RFP 769-22-100621MW

TITLE: *Classroom Electronic Locking System*

## Addendum #3

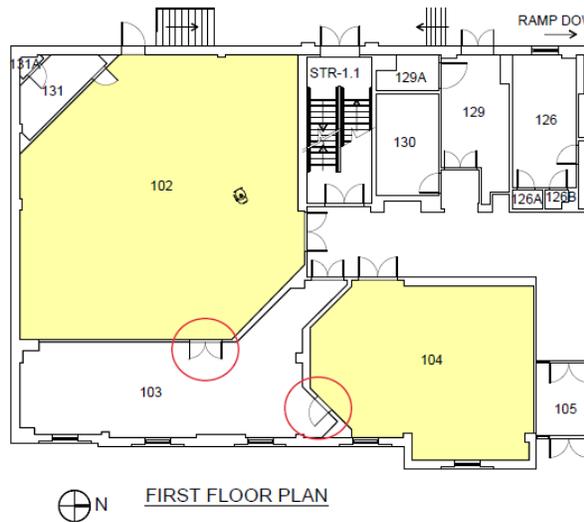
12. Addendum #2, “110 Classroom List”. The list does not contain any classroom referenced to buildings Hall Park A, or Hall Park B. Please confirm yellow-highlighted classrooms on the Hall Park B (BLDG #5002) should be included for pricing?

**Answer: The names of the buildings in our system are sometimes different than the name of the building. I have noted them below. You can include Frisco Inspire Park, Frisco Hall office A and Frisco Hall Office B as an alternate**

**Hall Park B is Frisco Hall Office Park B.**

**Frisco is Frisco Hall Office Park A.**

**Frisco Inspire is Inspire Park.**

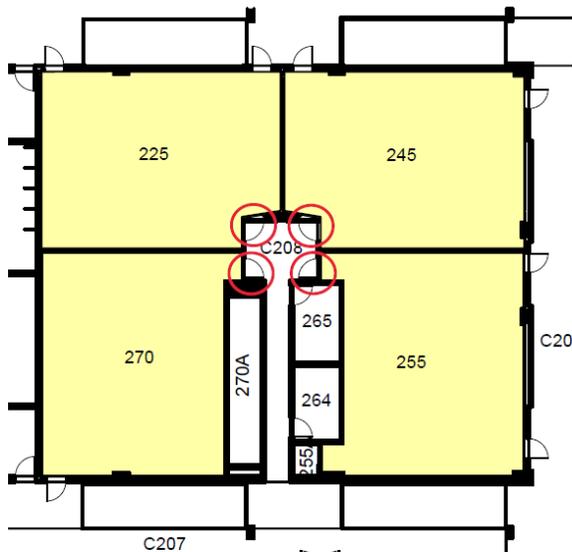
15. Where a 110 Classroom has an interior access portal via another room, should those doors also receive an e-lock? (Example is Physics Bldg. #0119, with doors in question circled red) Should the circled doors receive e-locks?

**Answer: The doors circled will not have e-locking because it is a door to a secured storage area. All doors that are used as egress or entrances for the classrooms should have e-locking.**
